香港城市規劃委員會依據城市規劃條例擬備的大埔分區計劃大綱圖
TOWN PLANNING ORDINANCE, HONG KONG TOWN PLANNING BOARD
TAI PO - OUTLINE ZONING PLAN

**SCHEDULE OF AMENDMENTS TO
THE APPROVED TAI PO OUTLINE ZONING PLAN NO. S/TP/24
MADE BY THE TOWN PLANNING BOARD
UNDER THE TOWN PLANNING ORDINANCE (Chapter 131)**

**Representation on the Draft Tai Po Outline Zoning Plan (No. S/TP/25)
Rail Operation Noise Concern**

Re: Draft Tai Po Outline Zoning Plan No. S/TP/25

Figure 4 *Rhodoleia championii*. This species has not been mentioned in the RNTPC Paper No.6/14

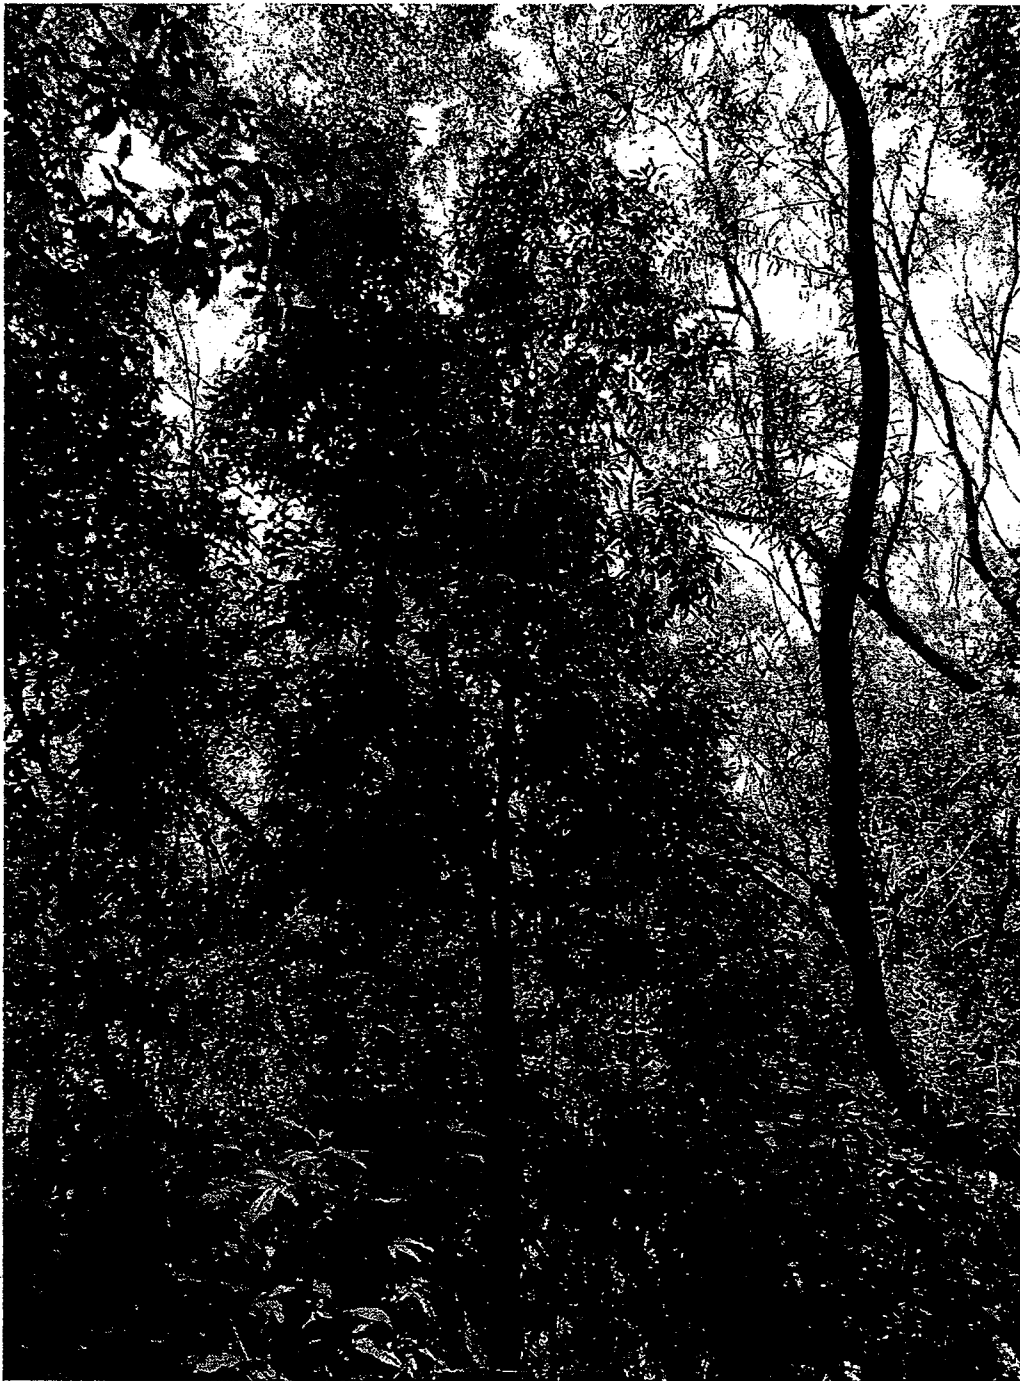
From both previous ecological study and site visit, species of conservation interest can be found in this Green Belt. We can spot *Rhodoleia championii* and *Pyrenaria spectabilis*, (Figure 4 and 5) and both species are protected under the Forestry and Countryside Ordinance (Cap 96), while at least one *Aquilaria sinensis* (Figure 6), listed under State Protection (Category II) and considered "Near Threatened" in the China Plant Red Data Book, can be spotted on the roadside of Sha Lo Tung Road. From the RNTPC Paper No.6/14, however, these species are missing in the evaluation.

Figure 7 Viewing the Green Belt site near Fung Yuen (circled in red) at Cloudy Hill (Kau Lung Hang Shan). After removal of massive number of trees, the residential blocks can be quite visible viewing from the uphill area

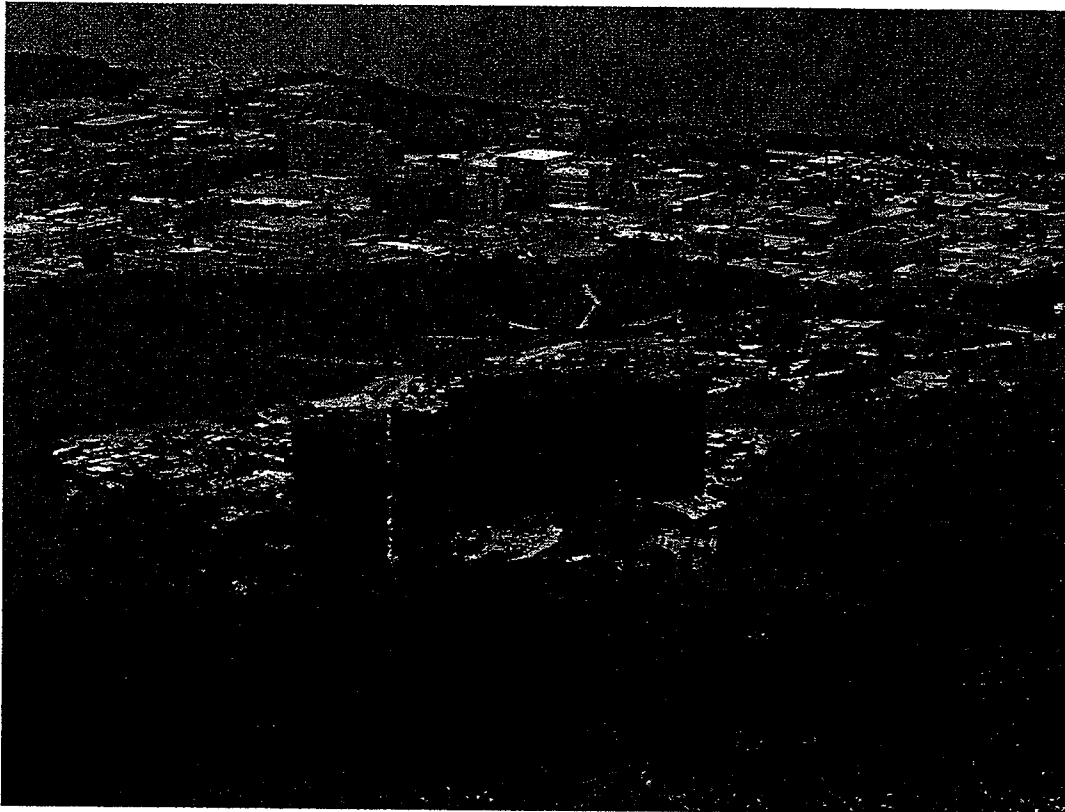
It was noted that only two view points, one at Ha Hang Playground and the other at the cycle track at Ting Kok Road, have been selected for assessing visual impact of the proposed residential development. However, we are quite concerned if another 2 view points, one at Cloudy Hill (Kau Lung Hang Shan) and the other at Fung Yuen Road (Kau Lung Hang Shan) (Figure 7 and 8), would indeed pose significant visual impacts on the area.

Figure 9 and 10 A water course flow from the northern portion of the site down to the area next to the temporary workplace by Highways Department and Water Supplies Department. Any development in the paved area in future might pose indirect impact to the water course.

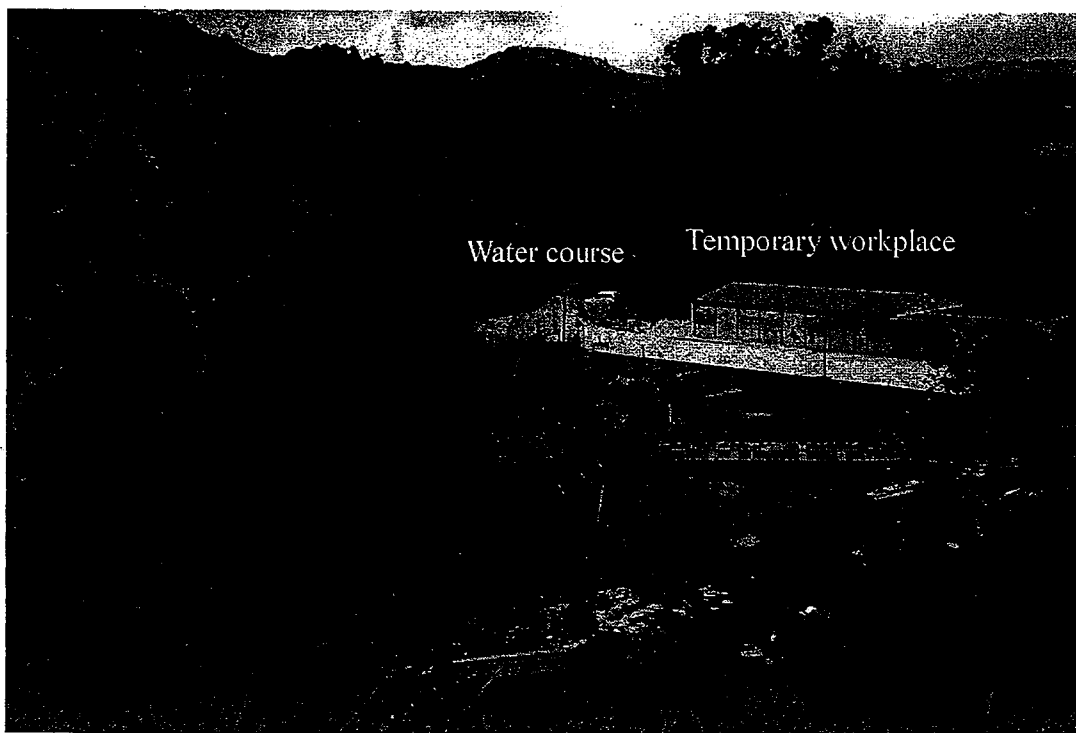
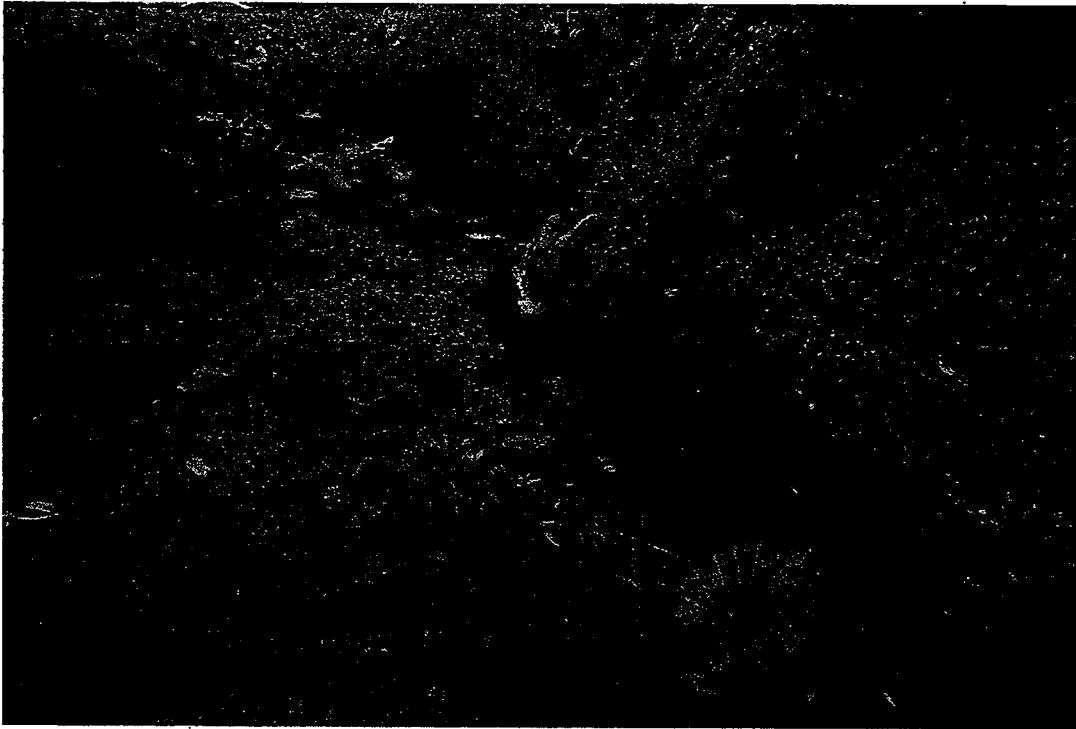
From our observation, a water course flows from the northern portion of the site down to the area next to the workplace of Highways Department and Water Supplies Department (Figure 9 and 10). Although Section 3.45 of the RNTPC Paper No.6/14 stated clearly that "*Avoidance of impact to this water course should also be duly considered*", we are still concerned about the potential indirect impacts posed on the section next to the workplace in both construction and operation phase.

Figure 11 The Green Belt (marked in yellow) is still well-covered by vegetation so that the zoning should remained unchanged

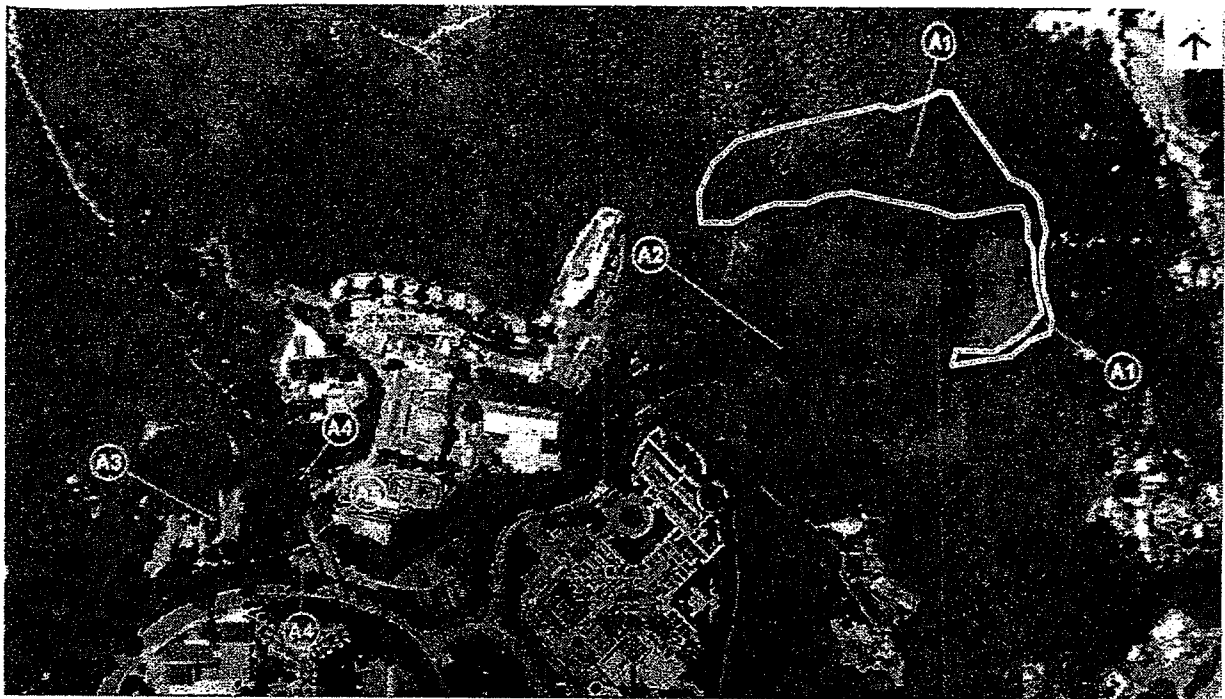
The Green Belt at this subject site is indeed a natural hillslope and covered by dense vegetation. It can still perform its function to act as a buffer within the urban periphery, and also Fung Yuen SSSI further north of the site. No changes should be proposed to this Green Belt (Figure 11).

Figure 4. The track leading to Cheung Uk was found to be widened in late 2013.

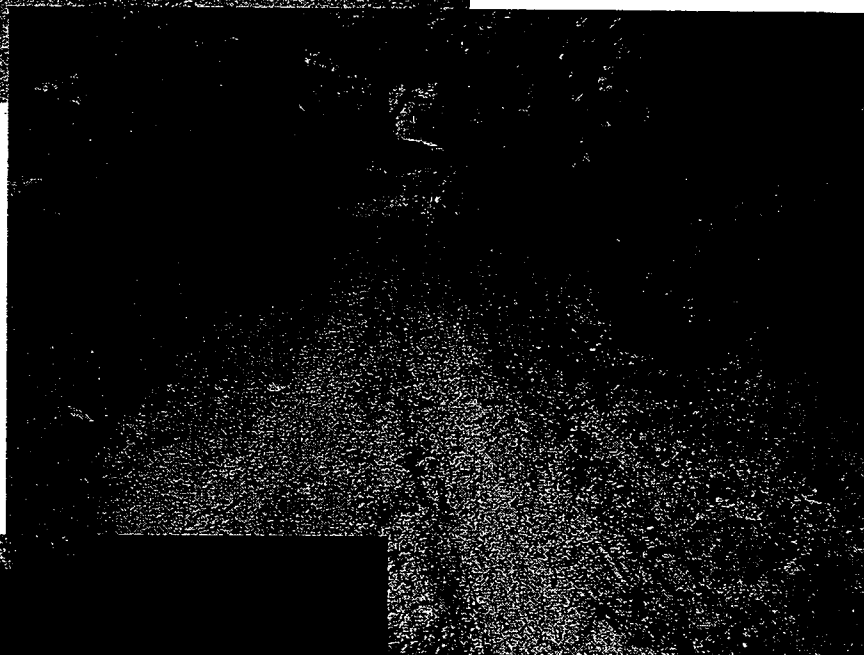
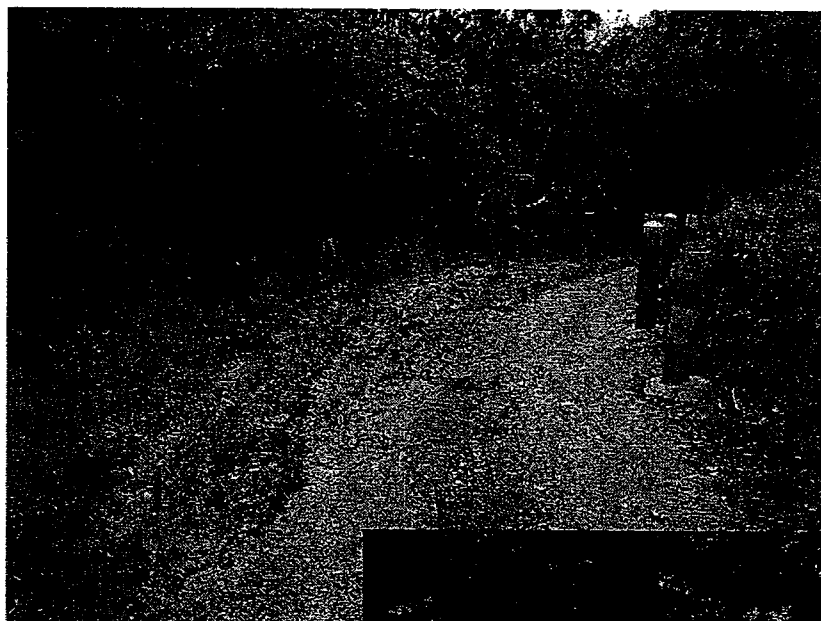
that a villager in Sha Lo Tung spotted a digger entering the village, and later on, the track leading to Cheung Uk was found to have been widened from two to three metres (Figure 4). We visited Sha Lo Tung after receiving the news, and noticed some vegetation was cleared near Lei Uk and concrete waste was dumped near the road next to the public toilet, and a stream was also partially blocked (Figure 5) by debris. Even though the Lands Department placed concrete bollards to try to halt the destruction, we are worried that the environmental degradation would be even more severe after the road condition of Sha Lo Tung is improved or upgraded due to the proposed housing development, thus, causing damage to the long term ecological integrity in the locality.

Location Plan
Objection to "Item E"
Tai Po Outline Zoning Plan No. S/TP/25
Scale 1 : 7 500

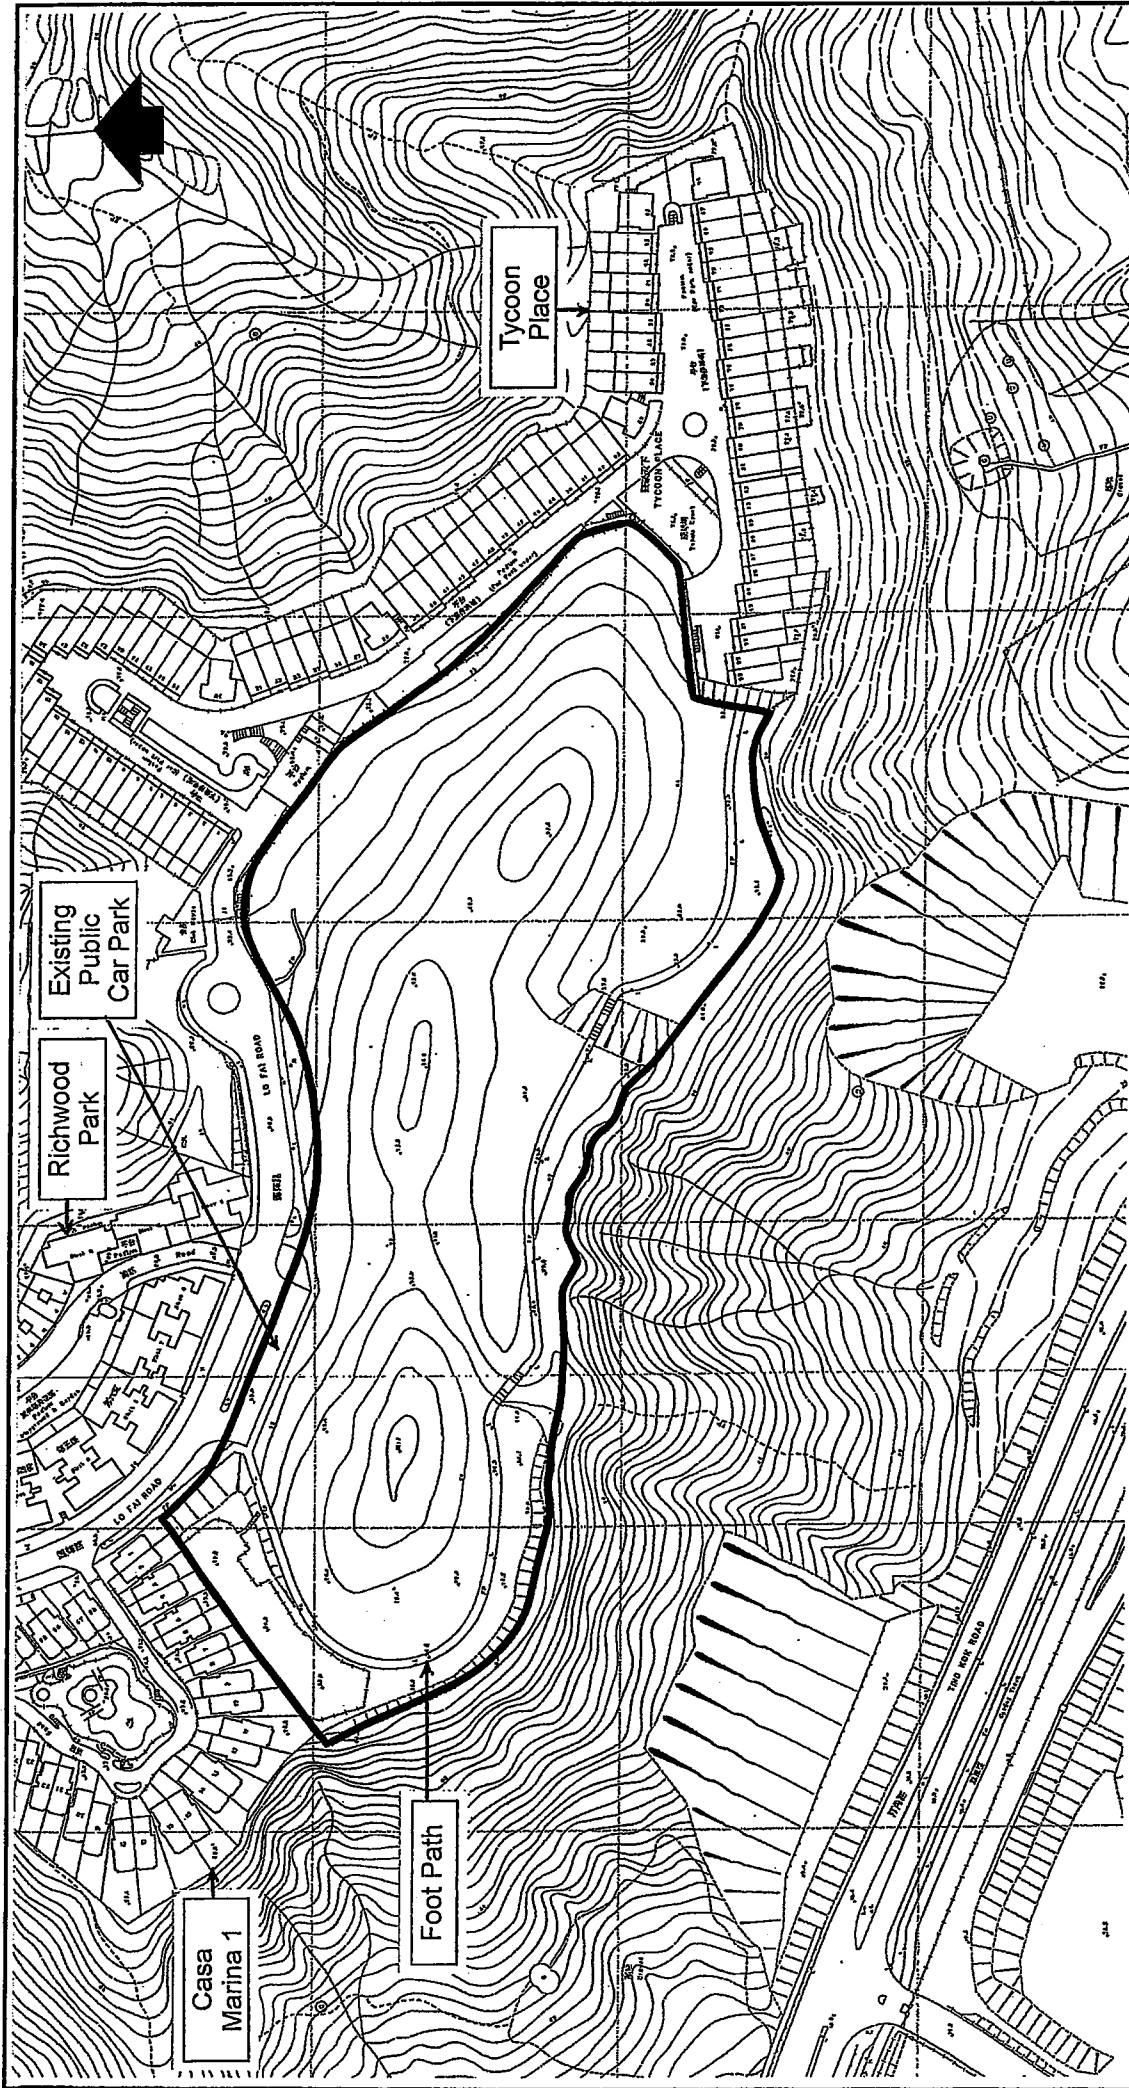
We object to amendment item E of the said OZP i.e. rezoning of a site (the Subject Site) at Lo Fai Road near Tycoon Place from “Green Belt” (“GB”) to “Residential (Group C)9” (“R(C)9”) and stipulation of building height restriction for the “R(C)9” zone. This planning statement will provide the analysis of the site context and the justifications for our objection.

We request the Town Planning Board (“TPB”) to revert the zoning of the Subject Site back to “GB”.

Figure 4.1 Photos of the Subject Site taken from Shuen Wan Golf Course

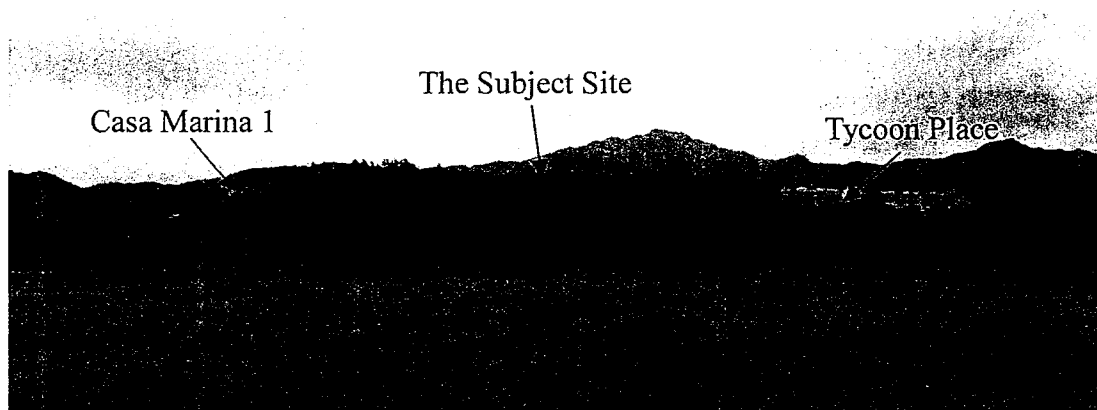
The Subject Site is located on the ridgeline of a local peak at Lo Fai Road. As shown in the photo taken from Tai Po Road in Figure 4.1, the dense vegetation of the Subject Site is an important visual feature in Tai Po, with the mature and dense trees defining the ridgeline. It is also an important visual relief and buffer for the two residential developments of Tycoon Place and Casa Marina 1.

Figure 4.2 Photomontage of Proposed Development (Viewing from Shuen Wan Golf Course)

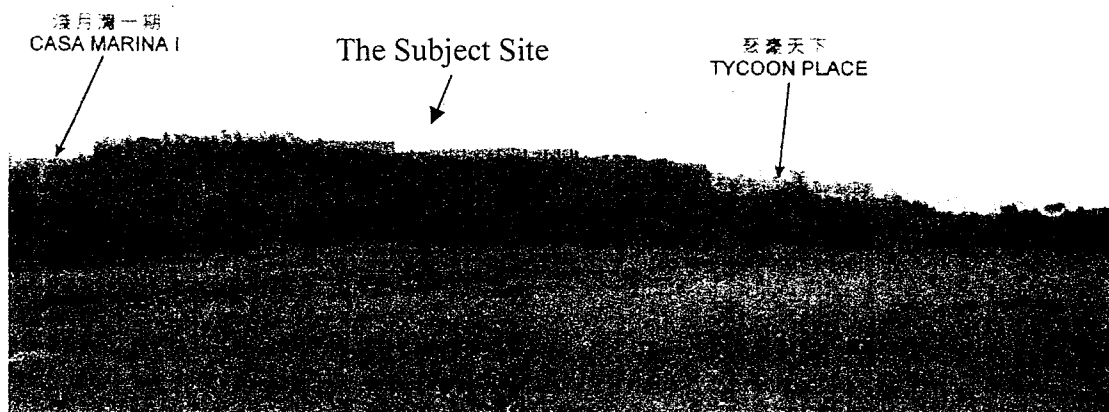
The proposed development at the Subject Site would destroy the natural ridgeline that defines the edges of Tai Po new town as well as vista points of the city and the country parks beyond, as shown in the photomontage prepared by Planning Department in Figure 4.2.

Figure 4.3 Location of a Devegetated and Formed "GB" Area in the Vicinity

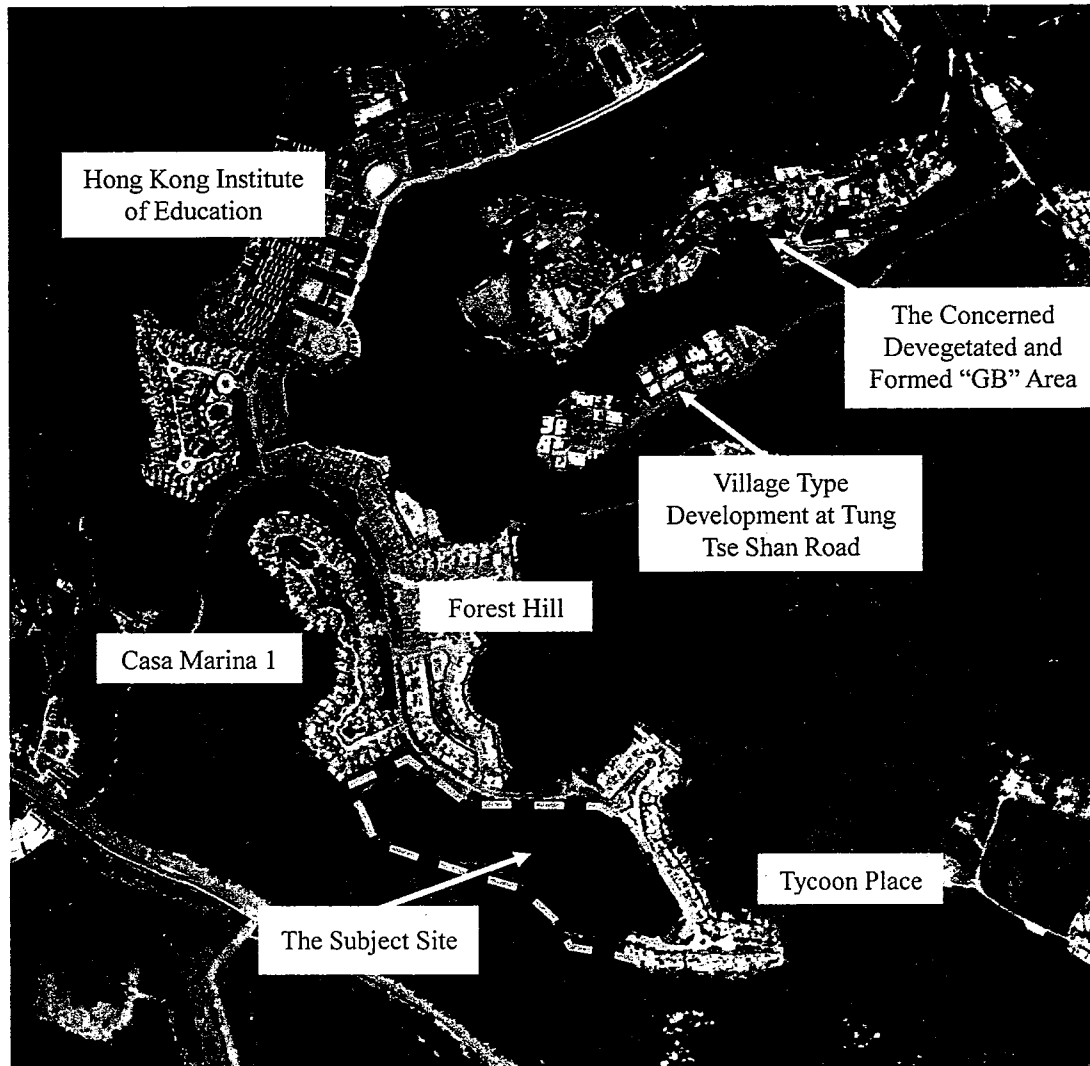
In the vicinity of the Subject Site, a “GB” area of about 6 ha was devegetated and formed and have been used for storage of construction materials and other open storage uses since 2000s (Photo 6). The area falls within “GB” on the same Tai Po OZP. Please refer to Figure 4.3 for the location of the concerned open storage area.

Since there is a much better alternative devegetated and formed “GB” site in the vicinity, it is unjust to rezone the Subject Site which is vegetated with mature trees for residential use. The government should make efforts to pursue CE’s policy objective to rezone devegetated, deserted or formed “GB” sites for residential use rather than rezoning the Subject Site which is currently covered with mature trees and dense vegetation.
